MILITARY SPECIFICATION

MICROCIRCUITS, DIGITAL, BIPOLAR, ADVANCED SCHOTTKY TTL,
PARITY CHECKER, MONOLITHIC SILICON

This amendment forms a part of MIL-M-38510/349A, dated 1 October 1986, and is approved for use by all Departments and Agencies of the Department of Defense.

FIGURE 4. Burn-in and life test circuit - Continued.

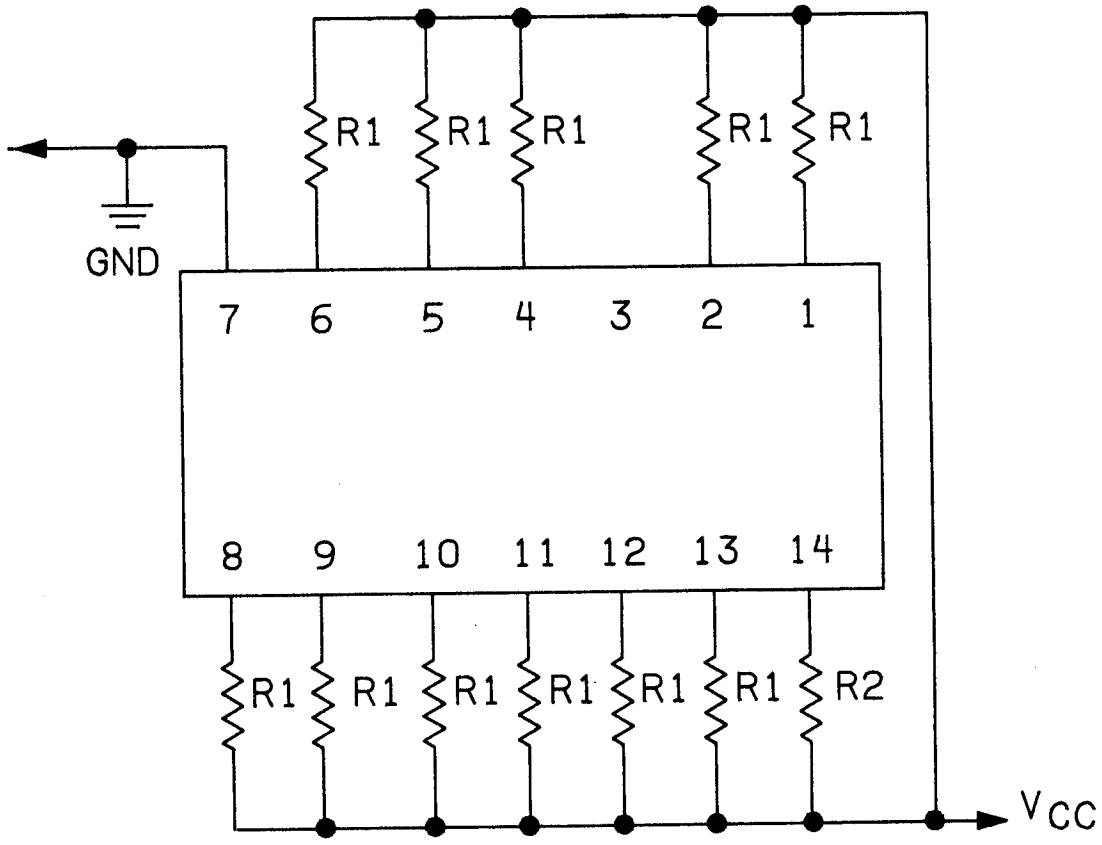
NOTES:
1. High temperature condition F, burn-in circuit only.
2. R1 = 2 kΩ
3. R2 = 2Ω .
